TECHNISCHE INFORMATION NR. SI36-063

SERVICE INFORMATION NO. SI36-063

EASA Notfalls- Lufttüchtigkeitsanweisung
Nr: 2011-0067-E

REPLACEMENT OF WASHER PART NO. 944072 (FLY WHEEL HUB) FOR ROTAX® ENGINE TYPE 912 AND 914 (SERIES)

BILD 1

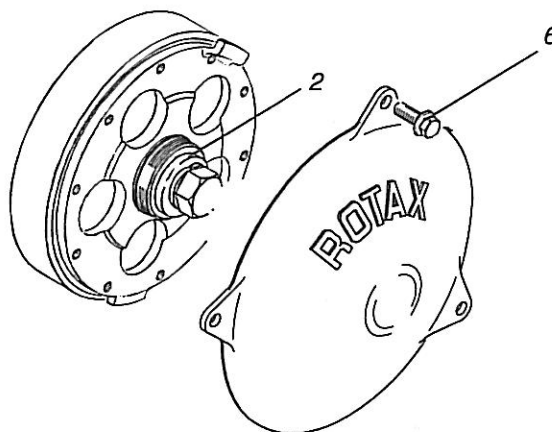
3.1) Austausch der Scheibe TNr. 944072

Siehe dazu Bild 1.

1. Zünderdeckel (1) abbauen.
2. Kurbelwelle fixieren gemäß entsprechendem Wartungshandbuch (Line).
3. Demontage der Sk-Schraube (4) gemäß entsprechendem Wartungshandbuch (Heavy).

■ ACHTUNG: Bei der Montage ist die neue Scheibe (2) TNr. 944072 zu verwenden.

■ ACHTUNG: Sollte sich die Magnetnabe während der Demontage lösen bzw. bei Unklarheiten, so ist die Magnetnabe gemäß entsprechendem Wartungshandbuch zu demontieren, zu reinigen und wieder zu montieren. Das Anzugsdrehmoment der Sk-Schraube beträgt in diesem Fall 45 Nm +180° Drehwinkel.

4. Montage der Sk-Schraube (4). **Anzugsdrehmoment 120 Nm.**

5. Kurbelwellenfixierung lösen gemäß entsprechendem Wartungshandbuch.
6. Geberspalt kontrollieren, gegebenenfalls erneuern gemäß entsprechendem Wartungshandbuch.
7. Zünderdeckel (1) montieren. Sk-Schrauben (6) mit Loctite 221 sichern.
Anzugsdrehmoment 5 Nm.

Fig. 1

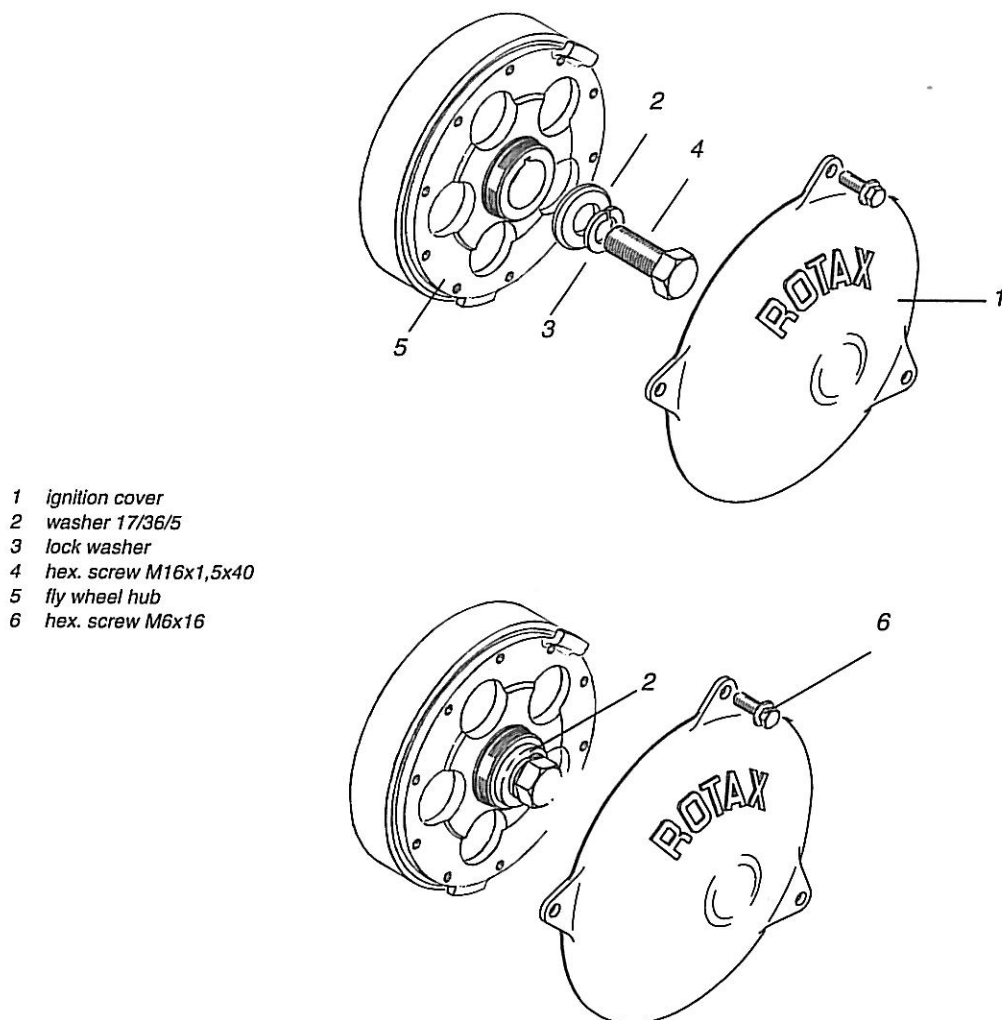
3.1) Replacement of washer part no. 944072

See fig. 1.

1. Remove ignition cover (1).
2. Lock the crankshaft in accordance with the relevant Maintenance Manual (Line).
3. Remove hex. screw (4) in accordance with the relevant Maintenance Manual (Heavy).

■ CAUTION: During installation the new washer (2) part no. 944072 must be used.

■ CAUTION: If the fly wheel hub has loosened during the disassembly and/or in case of doubt, then remove, clean and install the fly wheel hub in accordance with the relevant Maintenance Manual. In this case the tightening torque is 45 Nm (33.2 ft.lb) + 180° angle to rotation.

4. Install hex. screw (4). **Tightening torque 120 Nm (89 ft.lb).**

5. Remove locking pin of crankshaft in accordance with the relevant Maintenance Manual.
6. Check trigger coil gap, if necessary adjust it in accordance with the relevant Maintenance Manual.
7. Install ignition cover (1). The hex. screws (6) are locked with Loctite 221. Tightening torque 5 Nm (44 in. lb.).
